Technical Bulletin T773

Product: A/V Receiver

Hardware Technical Bulletin: T773-H2004-02

Subject: HDTV Component
Video change

Figure1

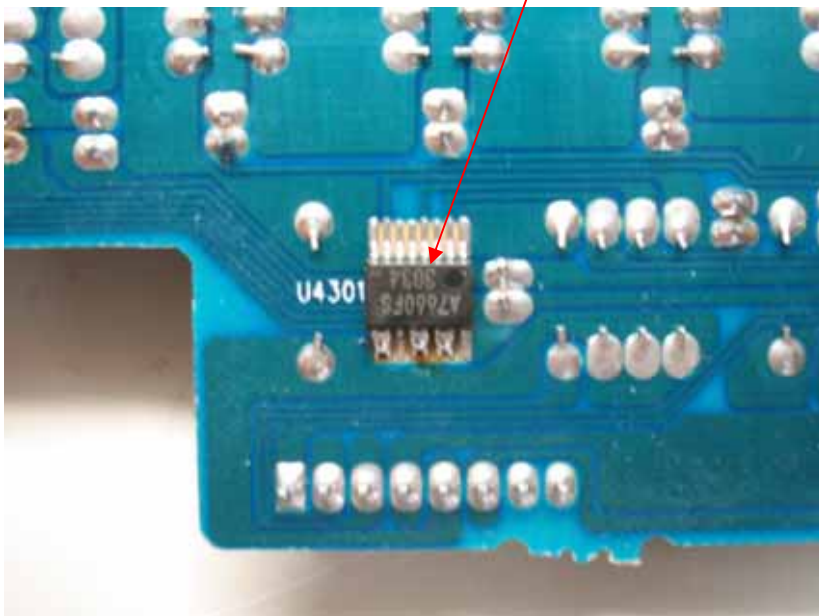
On the component video PCB U4301

- A) Link the following pins on U4301;
- Pins 9 to 10
 - Pins 12 to 13
 - Pins 14 to 15

Figure 2

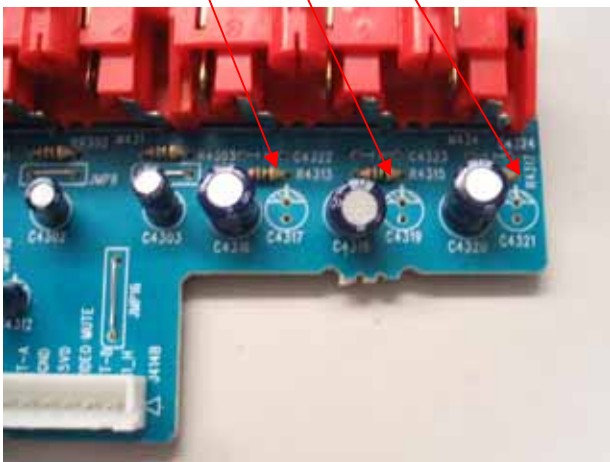
B) Remove C4317, C4319, C4321.

Figure 3

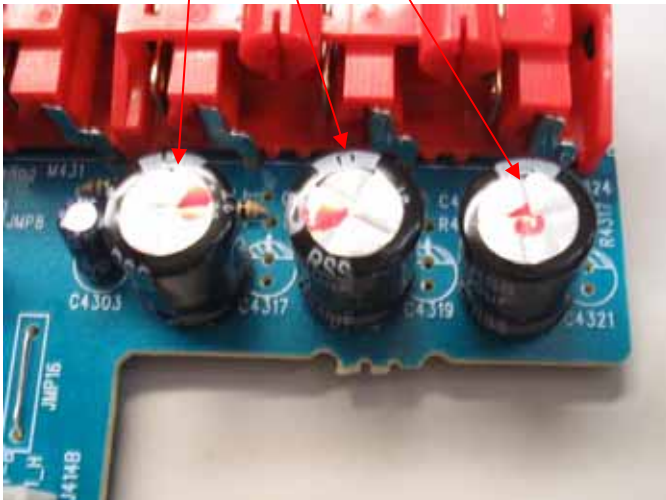
C) Replace C4316, C4318, and C4320 with 1000 uF 6V.
